Summary of Items Discussed in 2/2021 APSEC Discussion Forum on 19 March 2021

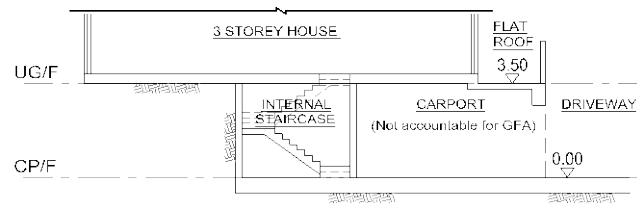
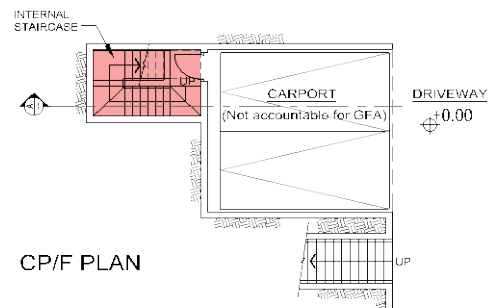
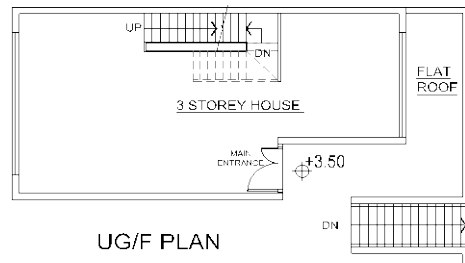
3. **PNAP APP-2 - Non-Accountable Gross Floor Area**
- Referring to item 11 of ADF 2/2020 held on 29 May 2020, BD confirmed that where staircases and lift shafts solely served floors accepted as not being accountable for GFA, the area of the features might also be discounted.
- For house development with first residential floor located at UG/F due to topographical feature (below diagram refers), it is our understanding that the internal staircase (coloured pink) solely serving the carport (not accountable for GFA) should also be discounted from GFA calculation.
- Please advise if our understanding is correct.

BD advised that in general, the internal staircase solely serving the carport (not accountable for GFA) in house-type development should not be accountable for GFA. However, it was not uncommon that private carports under houses were enclosed for unauthorised use. In this connection, layouts that prone to abuse would not be accepted.

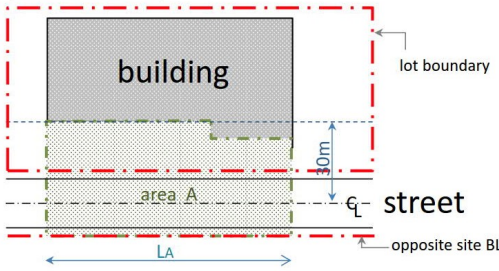
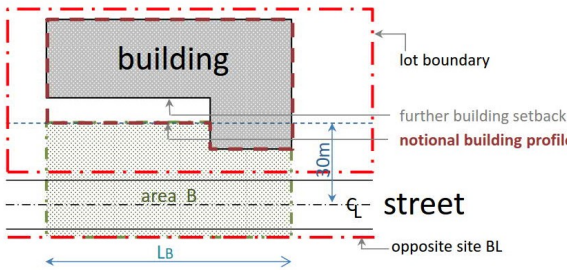
4.	<p><u>PNAP APP-152 – U & Max. Permissible Lp</u></p> <p>According to paragraph 2.3 of Appendix B of PNAP APP-152, if only a part of the building is within 30m from the centreline of the street, U is the mean width of the street canyon that abuts such part of the building as shown in Scenario A. We would like to enquire if it is acceptable to adopt a “notional building profile” when assessing the mean width of the street canyon where more setback area is indeed provided for better street environment as shown in Scenario B.</p>	<p>BD advised that according to paragraph 2.3 of Appendix B under PNAP APP-152, U was the mean width of the street canyon that abutted such part of the building within 30m from the centreline of the street. It served the purpose of determining the maximum permissible Lp in which no notional building profile would be allowed. Figure B7 in Appendix B of PNAP APP-152 was relevant.</p> <p>According to paragraph 12 of PNAP APP-152, in recognition of such genuine constraints in meeting the prescriptive requirements, the BA takes a flexible and pragmatic stance when considering applicants’ proposals holistically to achieve the objectives of the SBD Guidelines. In this regards, AP may consider to adopt the alternative approaches set out in Appendix E to PNAP APP-152.</p>

<p>Scenario A</p>  <p>lot boundary</p> <p>building</p> <p>10m</p> <p>area A</p> <p>street</p> <p>opposite site BL</p> <p>L_A</p> <p>$U_A = \text{area A} / L_A$</p> <p>Scenario B</p>  <p>lot boundary</p> <p>building</p> <p>10m</p> <p>area B</p> <p>street</p> <p>opposite site BL</p> <p>L_B</p> <p>notional building profile</p> <p>further building setback</p> <p>$U_B = \text{area B} / L_B$</p>	
5.	<p><u>PNAP APP-130</u></p> <p>Item 8 of ADF 2/2015 held on 20 March 2015 acknowledged that HKIA's understanding, i.e. <i>Part III of Appendix A of PNAP APP-130 on guidelines on adoption of performance-based standards for natural ventilation could be applied to a room where the window could only meet the prescriptive natural lighting requirement under B(P)R 31 but not the performance requirement using UVA method</i>, was correct.</p>	<p>BD advised that HKIA's understanding was correct.</p>

SECTION FROM G/F-2/E (1:100)

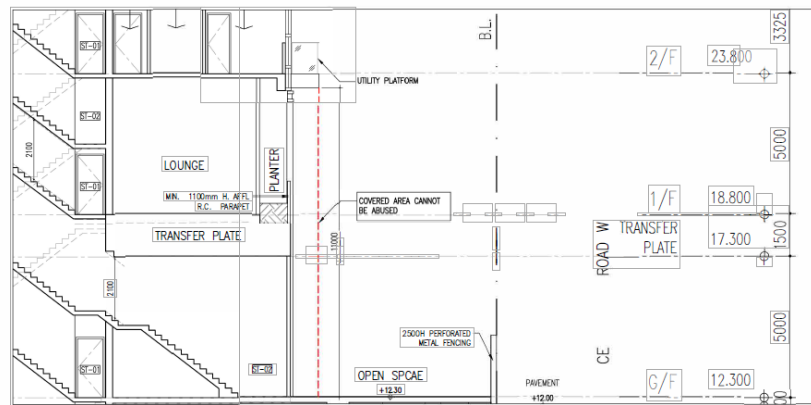
10.	<p><u>Recessed Discharged Point at Ground Storey</u></p> <p>Referring to item 9 of ADF 2/2012 held on 16 March 2012, BD advised that the ground storey discharge point which was recessed from the ultimate edge of the building (recessed covered area) would be counted for SC and PR.</p> <p>Recently, some BD officers requested the calculation of SC and PR for the exit route from staircase on ground storey common area under the cover of balcony/UP, in which the balcony/UP was more than 10m above the ground storey as shown in below diagram. It is opined that the balcony/UP at such height does not constitute any effective covering and abuse of use is unlikely. For this case, would BD consider disregard the SC and PR calculation for such location as the abuse of use is highly unlikely.</p>	BD advised that as per item 9 of ADF 2/2012 held on 16 March 2012, the covered area of recessed MOE discharge point should be counted for SC and PR.

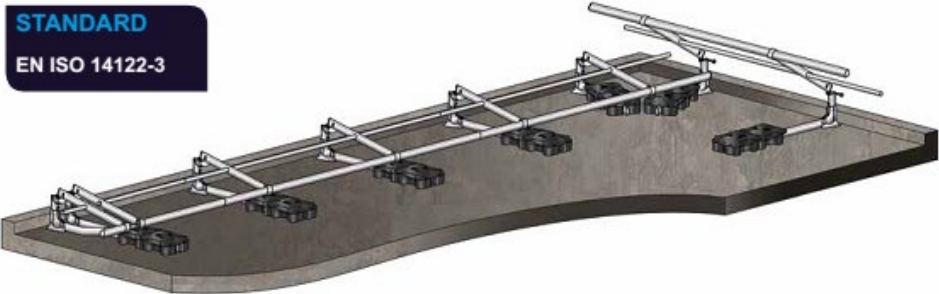
15.	<p><u>Safety Measures for Inaccessible Roof</u></p> <p>Further to item 4 discussed in ADF 1/2021 held on 22 January 2021,</p>	BD advised that the matter should be considered holistically and

<p>according to paragraph 4.2.3 in Part 2 of the CoP on Design for Safety - External Maintenance 2021 (the “Code”), <i>“Where stepping onto the inaccessible roof for M&R works is required, safety measures such as guard-rails with toe boards shall be provided at the edge of the roof in accordance with the requirements set out in paragraph 4 of Appendix D”</i>.</p> <p>Please clarify whether something like collapsible railing or folding guard rail system can satisfy the above requirements. Example of product can be found in the market:</p> 	<p>members may provide further details including but not limited to (i) the hardship in complying with the relevant requirement under the Code; (ii) the operation and technical specification of the proposed guard rail system; (iii) overseas examples; and (iv) demonstration on compliance with the relevant requirements of Labour Department under Construction Sites (Safety) Regulations for BD’s further consideration and deliberation in the Technical Committee.</p>

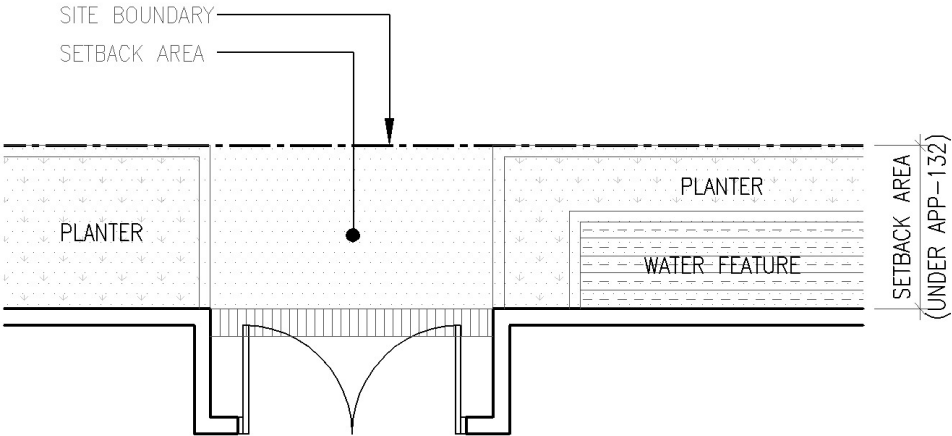
16.	<p><u>Landscaped Features at Setback Area</u></p> <p>According to PNAP APP-132, , BD would consider applications for relaxation of site coverage under paragraph 3 on ‘Set Back Approach’, subject to certain conditions and <i>“on the ground of setting back a building for its full height from a site boundary abutting on a street”</i>. Sub-paragraph 3(d) further provides that <i>“the setback area is properly landscaped and/or paved and open, uncovered and without any permanent</i></p>	<p>BD advised that water feature which would contribute to improving street environment were acceptable to be provided at the setback area under PNAP APP-132.</p>

<p><i>building structures other than the landscaped features and perforated boundary walls”.</i></p> <p>We considered that water features may be permitted in such set back area and is an acceptable landscaped features. Please confirm if our understanding is correct.</p> <p>(cross reference to paragraph 2 of Appendix D of PNAP APP-152 about water features which are listed as greening features in such set back area under SBD Guidelines.)</p> 	
17.	<p><u>Access for Inspections and Maintenance of External Drainage Pipe</u></p> <p>Referring to PNAP APP-93 for the maintenance of common pipe works within private areas, our understanding is that the delineation of common</p>	<p>BD advised that the access for inspections and maintenance of external drainage pipe enclosed by architectural features required under</p>

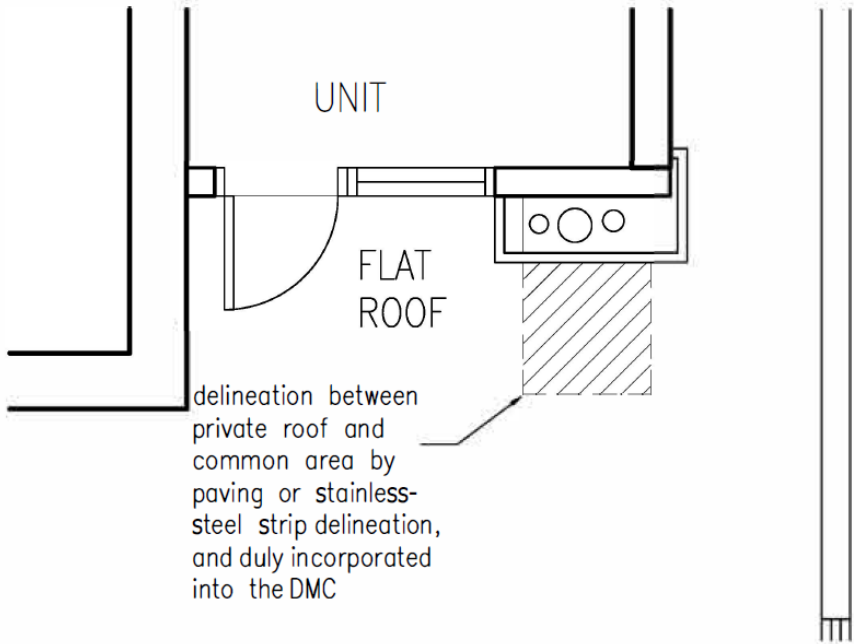
<p>areas reserved for maintenance/repair of common drainage pipes located on a private flat roof, by means of different paving, or by stainless-steel strip delineation, and to be incorporated into the DMC, would be acceptable. Please confirm if our understanding is correct.</p> 	<p>paragraph 7 of the PNAP APP-93 should be connected from the common parts of the building and shown on the submitted drainage plans and incorporated in the corresponding building plans. The requirements were further elaborated in paragraph 2.6 and 2.7 of Annex 1 of Appendix B to PNAP APP-93 as follows:</p> <p>2.6 The lowest level of the concealed space should be accessible from the common parts of the building.</p> <p>2.7 Adequate working space (including the lowest level of the concealed space) should be designated as common parts of the building for carrying out maintenance works.</p> <p>In the sketch plan provided by AAP, the means of access from the common parts of the building to the delineated area through the private flat roof and the adequacy of working space for carrying out maintenance works should be fully demonstrated.</p>

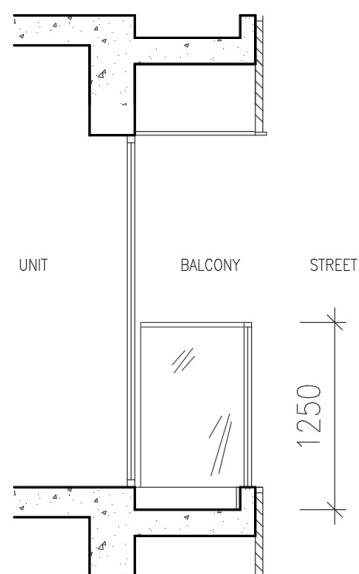
18.	<p><u>Height of Balustrade for Balcony & Utility Platform (UP)</u></p> <p>Referring to item 16 of ADF 2/2020 held on 29 May 2020, please confirm if the following understanding is correct:</p>	<p>For (1), BD advised that AAP's understanding was correct. B(P)R 31(1)(a) referred.</p>

- (1) The rectangular horizontal plane (RHP) does not apply to a prescribed window facing a specified street.
- (2) Hence, the deemed-to-be level of window sill of the prescribed window opening onto a balcony facing a specified street will not be blocked by balcony, UP, AC platform and the like.
- (3) Prescribed window area for inclusion into natural lighting and ventilation calculation can carry down to floor level irrespective to the deemed-to-be level of window sill height.

For (2) and (3), BD advised that AAP's understanding was correct. The deemed level of sill as stipulated under B(P)R 31(3)(b) was for the purpose of assessing RHP mentioned in B(P)R 31(1)(b). For windows, no matter facing street which was not less than 4.5m wide or facing an RHP, the superficial area of that portion of the glazing and window opening at level below 1m A.F.F.L. might also be counted towards the aggregate glazing area and aggregate openable window area as required under B(P)R 30(2)(a)(i) and (ii) respectively. Item 2 of ADF 5/2017 held on 17 November 2017 and item 16 of ADF 2/2020 held on 29 May 2020 were also relevant.

ORIGINAL OPEN KITCHEN LOCATION
 REQUIRED OPEN KITCHEN LOCATION

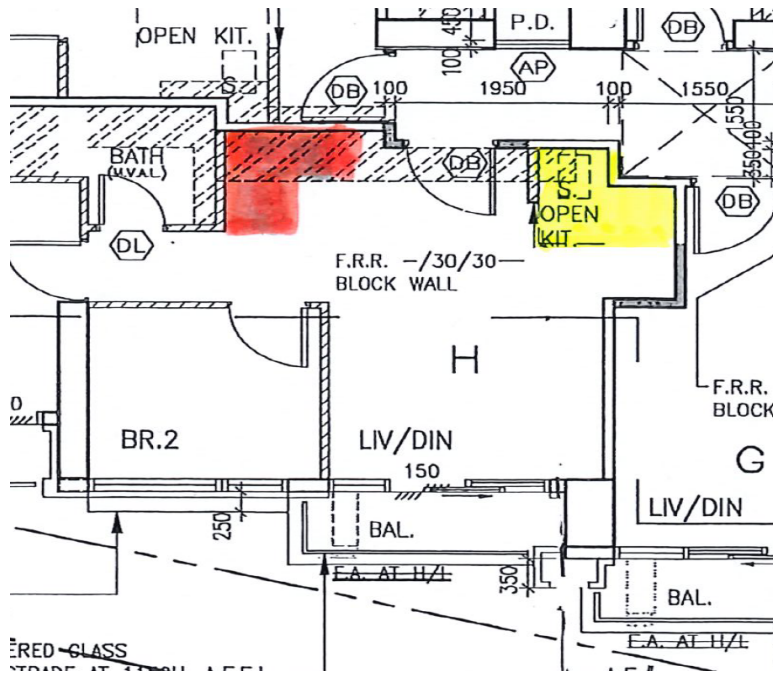
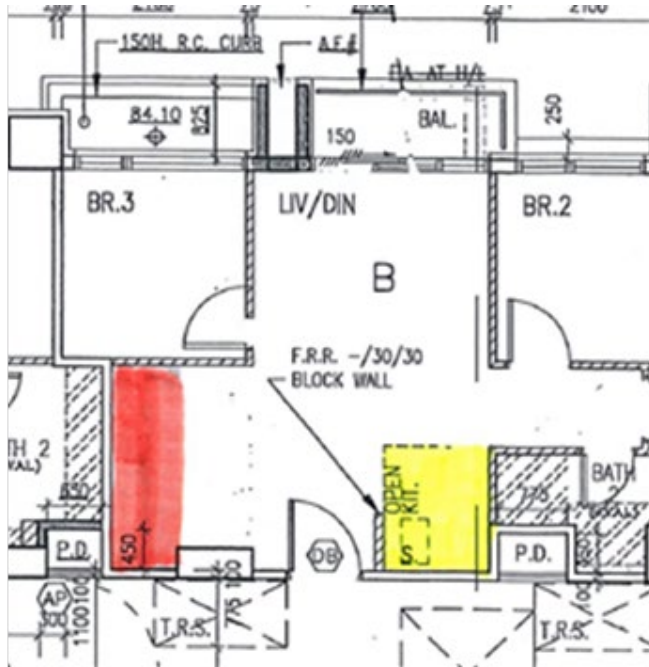
Location for Open Kitchen

Please refer to the below sketches. BD insisted the open kitchen shall face to window and rejected the AP's original proposal even the window is within 9m to the open kitchen.

We would like to seek clarification on the requirement.

BD advised that as per item 2 of ADF 3/2012 held on 18 May 2012, the open kitchen should be located in a position where most of the open kitchen area could face the concerned prescribed window(s) of the room for the required natural lighting and ventilation. To this end, the original locations of open kitchens in red colour as shown in HKIS's sketch were considered not acceptable.
